At the January 2022 Randolph Selectboard Meeting Brendan Malley, speaking for the Petitioner, told the Selectboard: (Exhibit MB-22 at 1:37:59 submitted May 6, 2022 with my prefiled testimony) [the state permitting process] “will govern things like runoff areas, whether you need level spreaders, or whether you need any number of other storm water management approaches implemented on the site.”

For the most part, the panels on the Petitioner's proposed array do not follow contour lines. Extreme engineering is required when panels are not on contours and the slope is greater than 15%. Some of that extreme engineering will be on Buckland PAS with slopes greater than 25%.

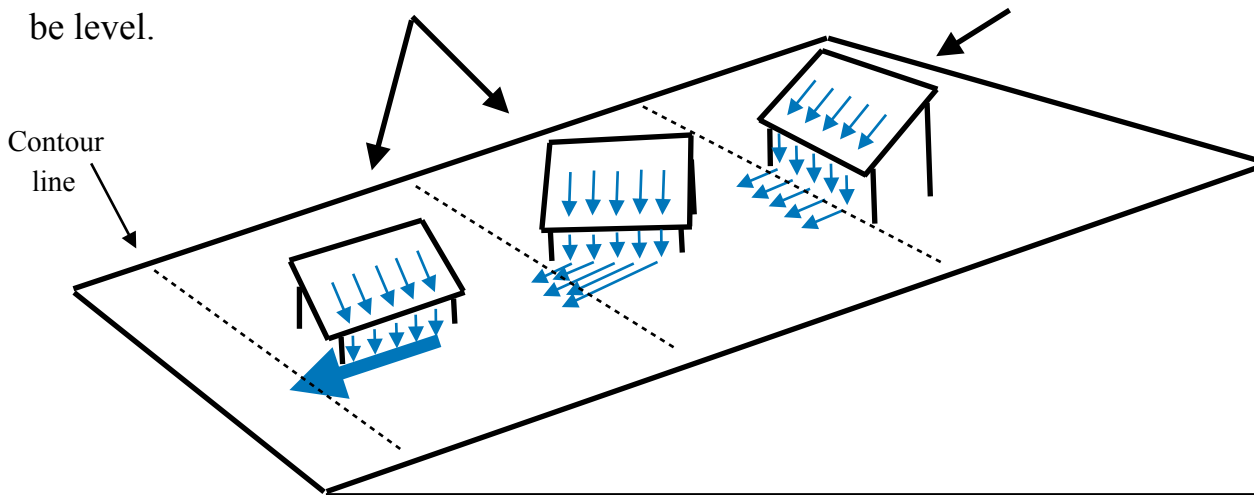
When the array does not follow contour lines, the panels concentrate water flow. Level Spreaders cannot be used under the drip edge because Level Spreaders need to be level.

When the panels and the ground slope in the same direction, the water may flow in a sheet. Level Spreaders are used if the slope is over 5%.

This clipping is taken from the 2nd Site Plan because it has clearer and finer contour lines than Site Plans 3 through 6. (The contour lines in site plans 3 through 6 are coarser and somewhat obscured by the slopes layer in those plans). See exhibit MB-39

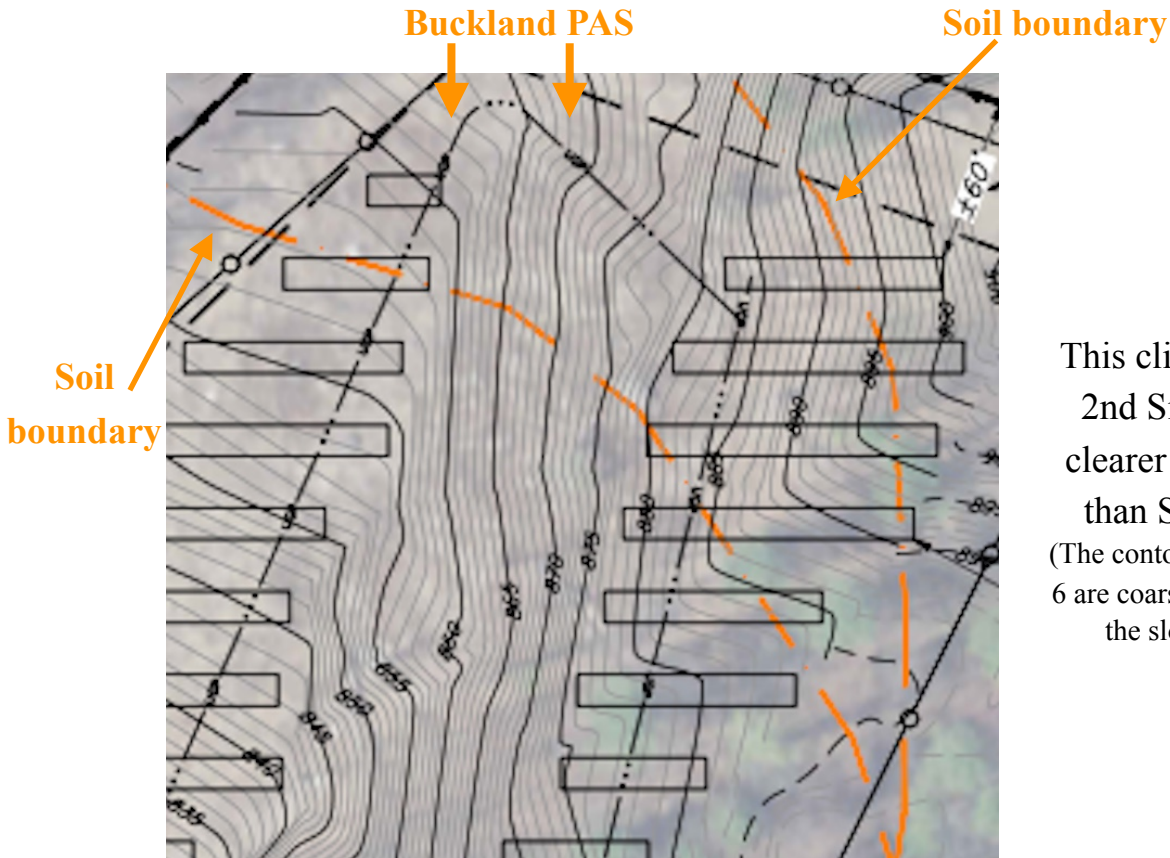
The array is perpendicular to the contour lines on steep soils, including PAS.
